APPROVED MEETING MINUTES

October 16, 2014

Waterfront – Main Corridor South of Union St and Kiosks

Meeting Summary

Buster Simpson's proposal for an "Anthropocene Beach" artwork.

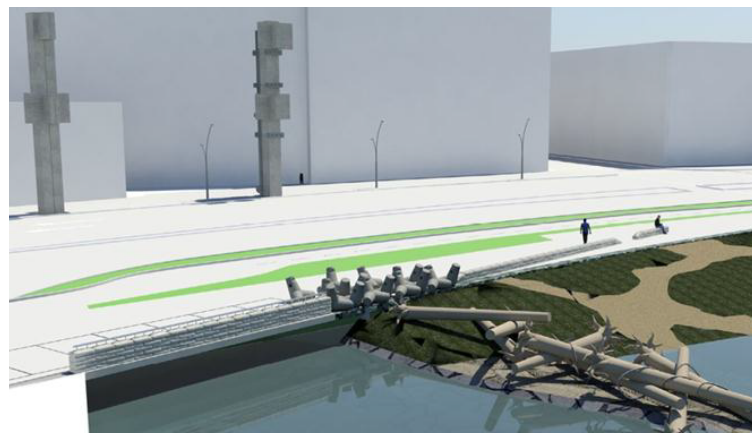
2. The Commission believes the Pioneer Square Beach is a fantastic asset and is encouraged by the integration of art in its design. Encourage Mr. Simpson to address sea level rise even more deeply. The "sandbags" are more successful when less ordered so that they do not function as a boundary.

Mimi Hoang presented the concept design for four kiosks along the waterfront promenade.

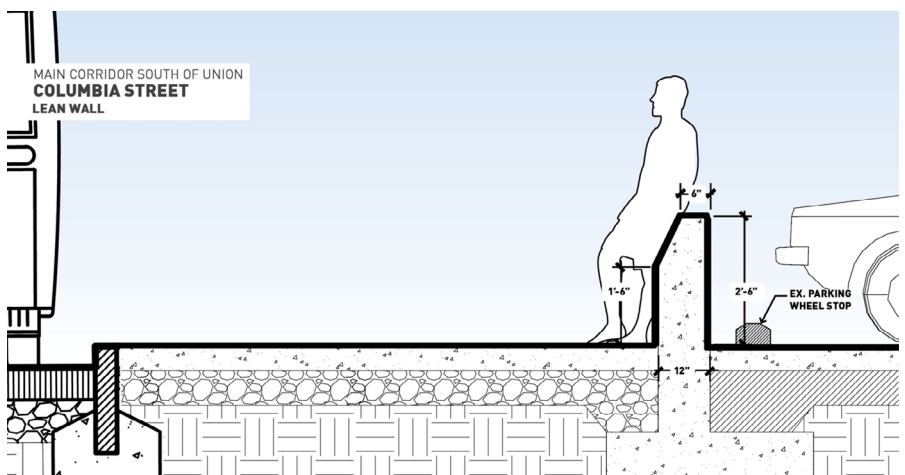
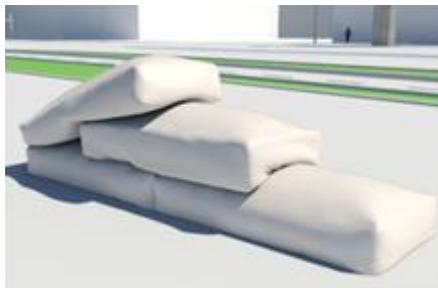
1. Explore in greater depth the scale of the kiosks, the relationship of the base to the upper portion, and the character of the doors.

2. Explore ways to introduce color into the design, perhaps internally to create a more dynamic presence.
3. Pay close attention to the specific placement of each kiosk, especially Spring St, to support the notion of these “social intersections” as areas of gathering. At schematic design, illustrate how each kiosk relates to the design, pedestrian circulation, and anticipated uses and activity for the entire intersection space. Evaluate aligning the kiosks with the piers and slips rather than parallel with the downtown street grid.
4. Continue evaluating the potential uses and functions of the kiosks. Provide a greater understanding of how they will operate successfully on the waterfront.

MAIN CORRIDOR SOUTH OF UNION **WATERFRONT RAILING** HANDRAIL

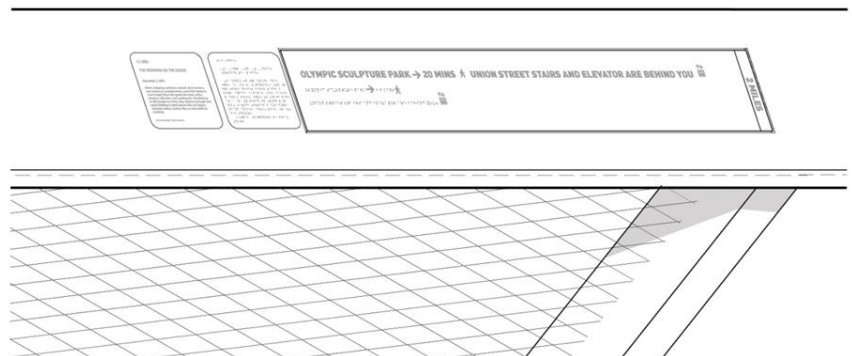
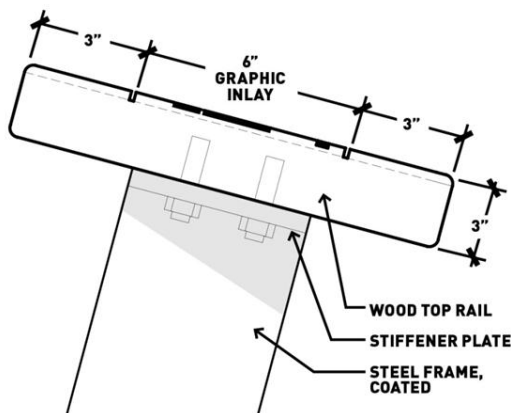
10. The Commission supports the overall direction for materials and in particular the use of wood for the railing. At the next review, provide more detail on the railing design, especially how the wood interfaces with the metal. Consider modifying the top of the railing in response to the character of each segment of the waterfront rather than a singular solution to the entire project area.
